Staff Memorandum

To: Salt Lake City Historic Landmark Commission
From: Carl Leith, Senior Planner
801 535 7758 or carl.leith@slcgov.com
Date: 20 April, 2017
Re: PLNHLC2016-00800 New Construction – Single Family Residence

NEW CONSTRUCTION – SINGLE FAMILY RESIDENCE

PROPERTY ADDRESS: 717 (previously 715) South 500 East
PARCEL ID: 1607229021 (previously identified as 1607229019)
HISTORIC DISTRICT: Central City Historic District
ZONING DISTRICT: H Historic Preservation Overlay District & RMF-30 (Low Density Multi-Family Residential District)
MASTER PLAN: Central Community Master Plan
DESIGN GUIDELINES: Historic Residential Design Guidelines (A Preservation Handbook for Historic Properties & Districts in Salt Lake City)

SITE & LANDSCAPE PLAN

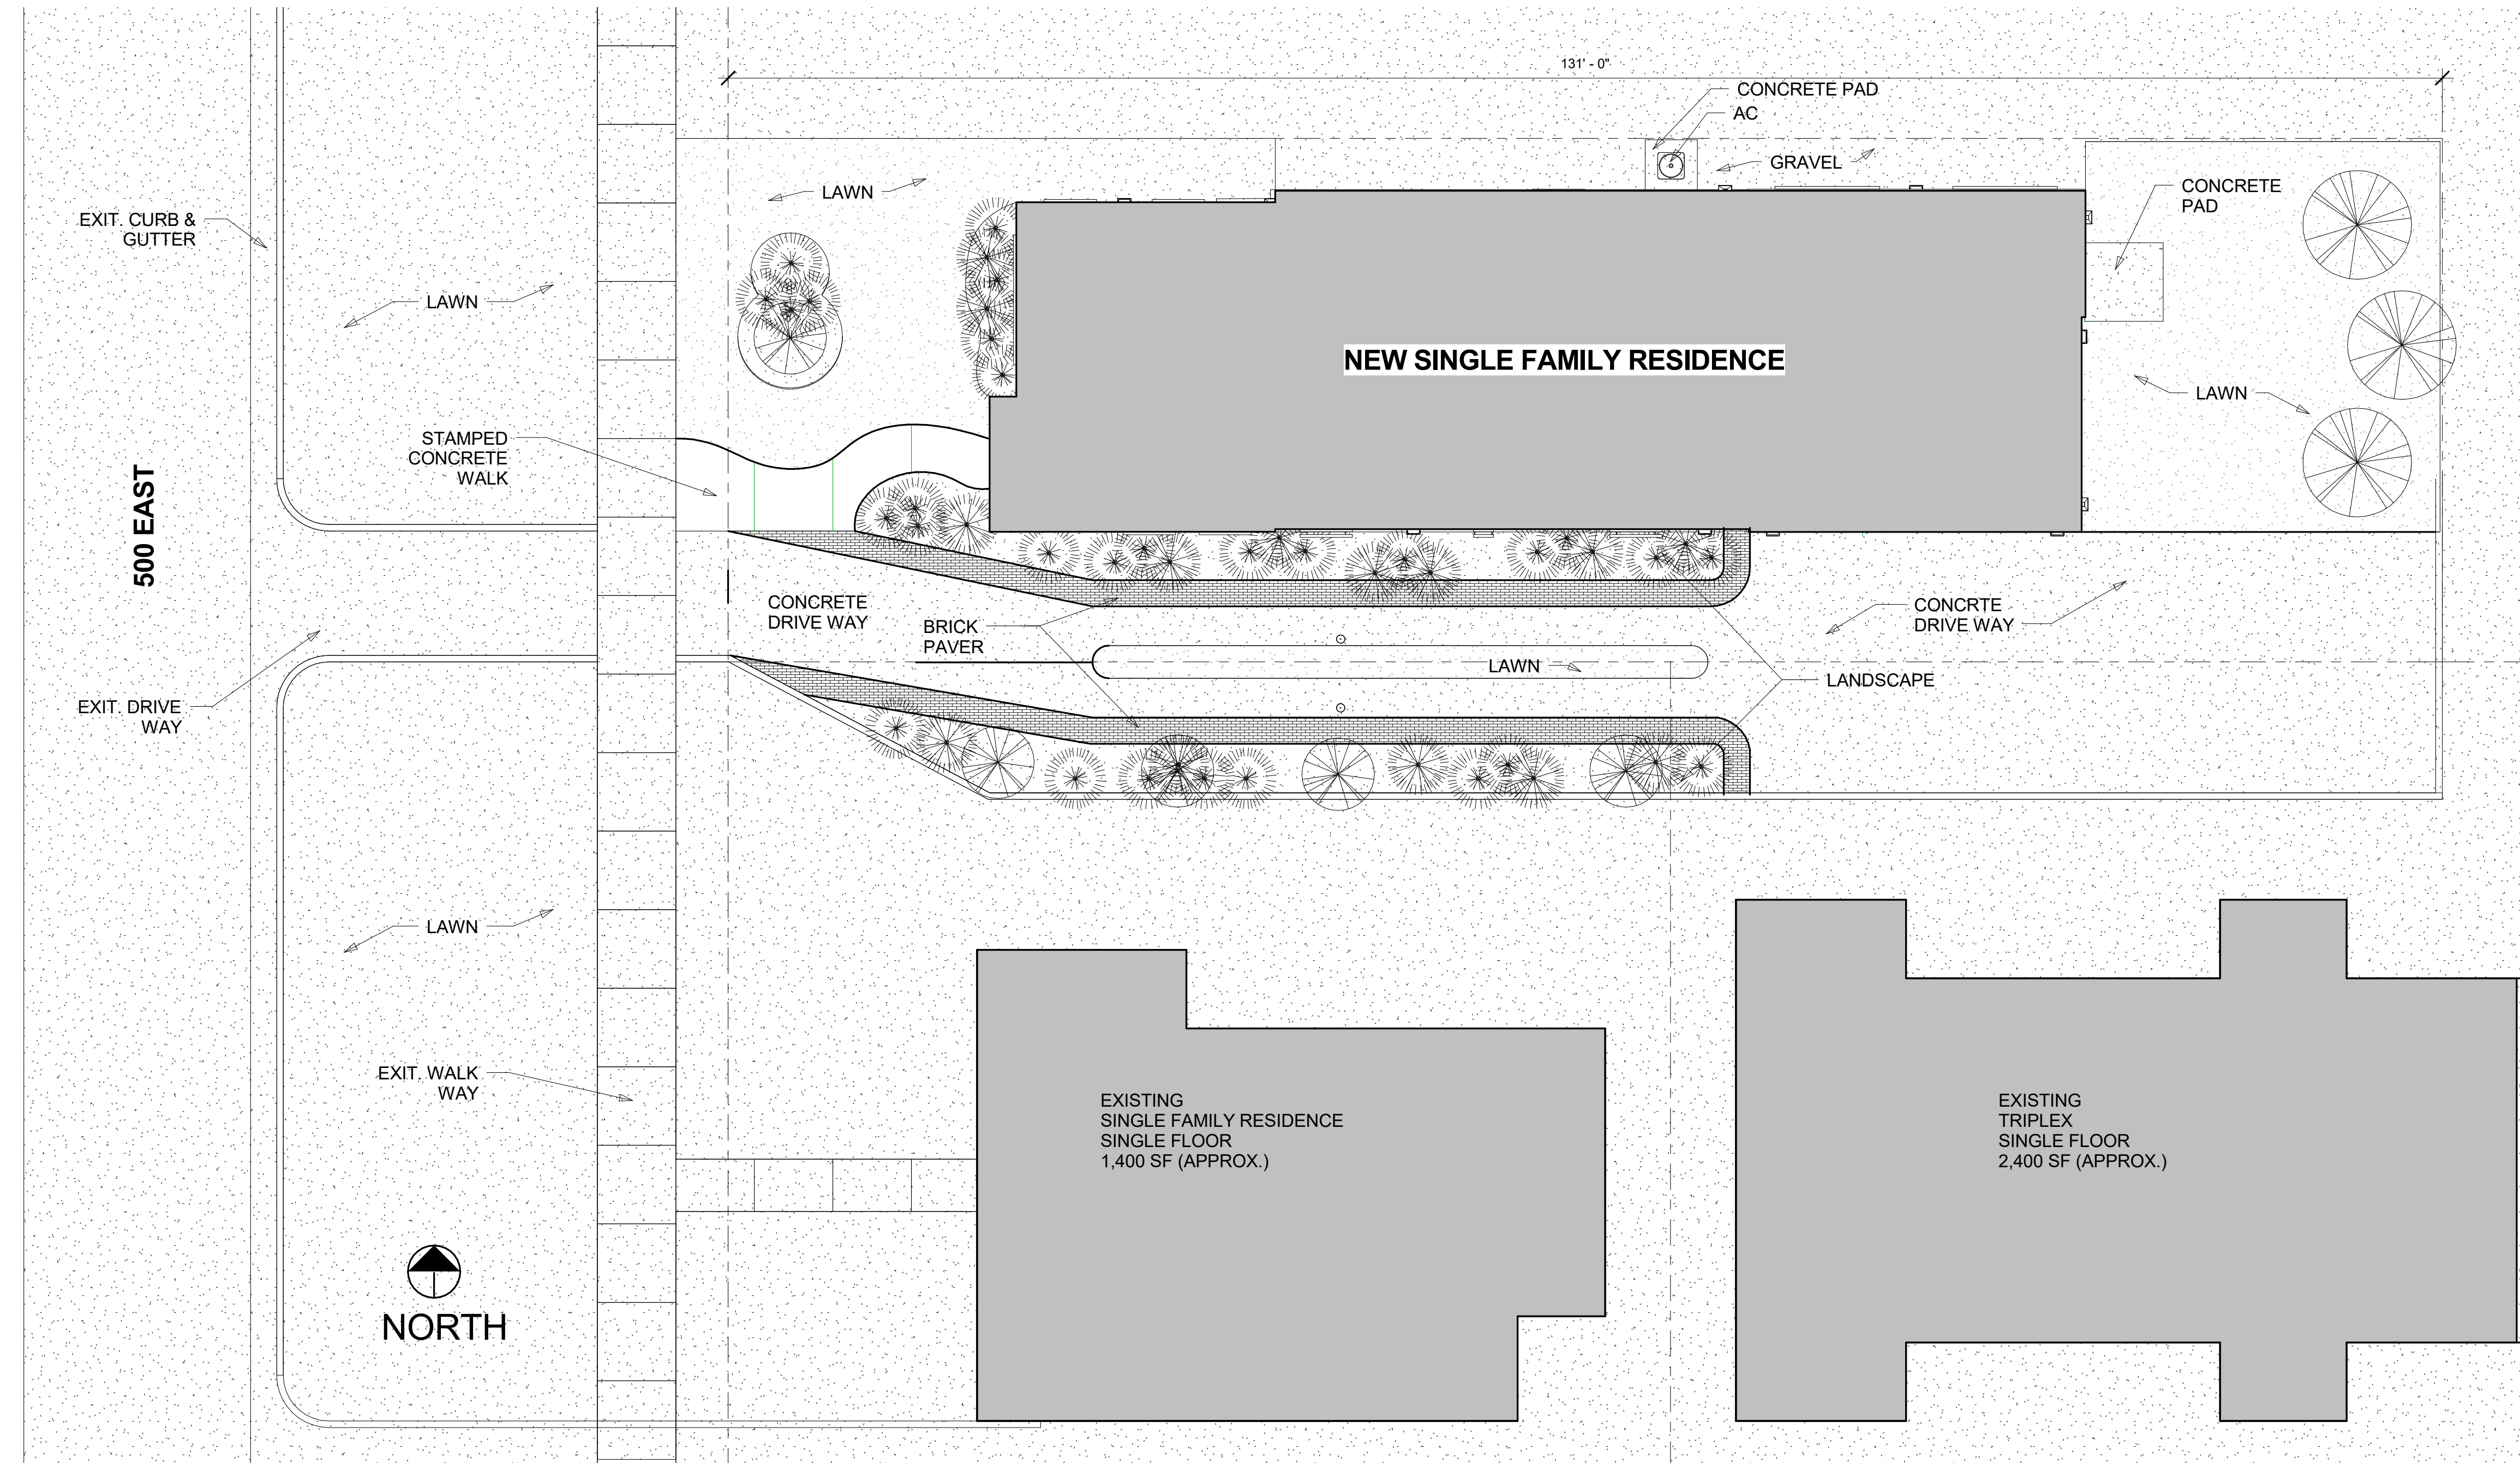
- Visualization was key for proposal such as this.
- If the Applicant would be willing to table the petition and revise some of the concerns expressed by the Commission.
- Presenting the site plan as a whole to include the surrounding structures.

- The stucco finish has scored/incised joint pattern.
- **Landscaping**
 - Additional consideration has been given to landscaping across the site, with confirmation that existing trees to the rear will be retained.

- A front pathway to the house has been added.

- Wheel strips are proposed for the drive rather than solid concrete paving to enhance the planted area and reduce heat gain.

Broke up the concrete from a single slab to tire track to break up the harshness that the concrete creates. Additional trees and shrubs enhance the site further.

3D VIEW

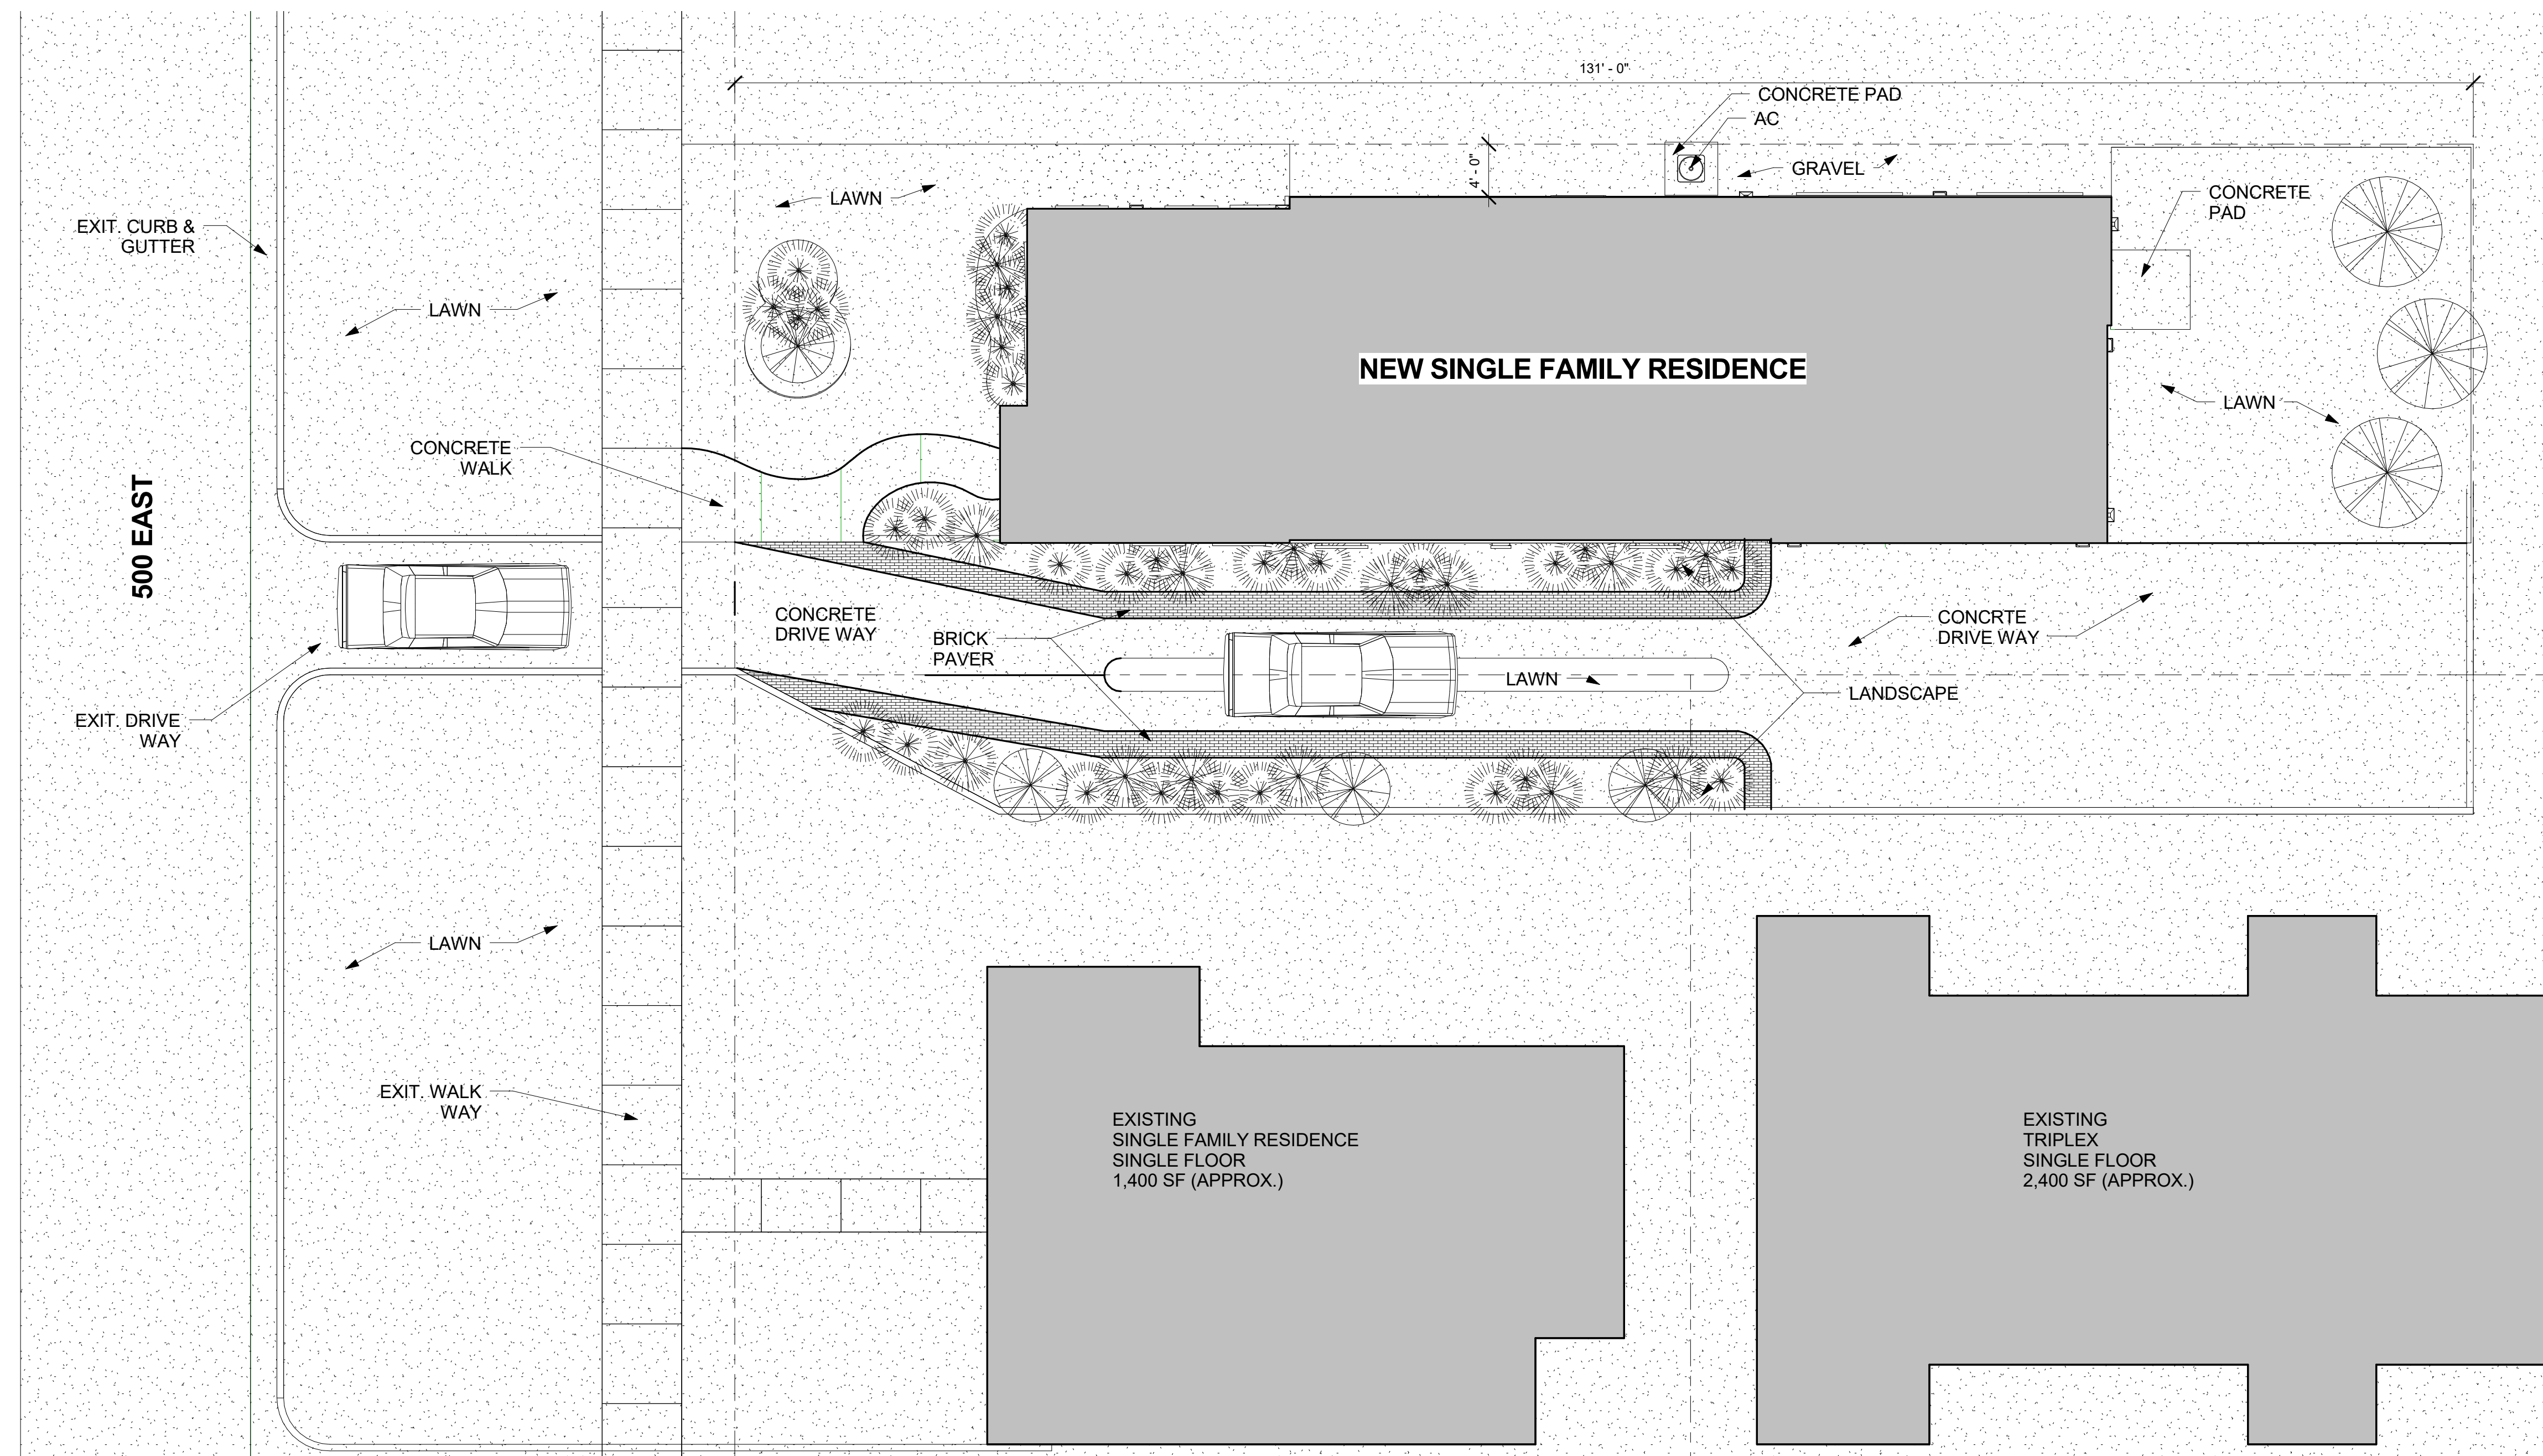
- The west elevation read as a commercial building and not a residence.
- The proposal looked like a first draft and needed to be improved.
- The massing and compatibility with the streetscape needed to be adjusted.
- The west façade was incomplete and needed more depth.
- There are commercial buildings in the area that the proposed west facade would blend with.
- The windows on the west could be changed to reflect the streetscape.
- The style of the window was out of character with the area and could be changed to make a huge difference.
- Refinements could be made to the materials, eave, overhang and the transition of the materials to make the building better fit the area.
- Building elements, such as awnings, could be added to the south façade to aid with the shade during the summer and visual interest.
- To table, deny or approve the petition.

- Development of hierarchy and windows on the west elevation.
- Refinement of the west elevation in general.
- Evolution of the south façade to address the window selection and articulation of shading of the windows to add depth and visual interest to the façade.
- Window type and window operation.
- The overall height needed to be evaluated and the form of transition between the wall and the roof.
- Review historic commercial structures and other examples in considering revision and refinement of the design.

- Window Hierarchy - Design has been revised to create a single, wide tripartite window on the main floor, tying in with the alignment of the windows above and establishing a more obvious design hierarchy than the previous height difference in the window openings.

- Window Type - The design has been revised to include opening casement windows on both floors on this street facing facade.
 - Front Porch - This has been reviewed by the applicant, with no changes proposed, concluding that the design of the upper level porch is counterbalanced by simpler ground level porch.

- **South Façade**
 - The design has been revised to include a tall window to the stairway.
 - Window definition now employs a cultured stone sill with a cedar-clad header.
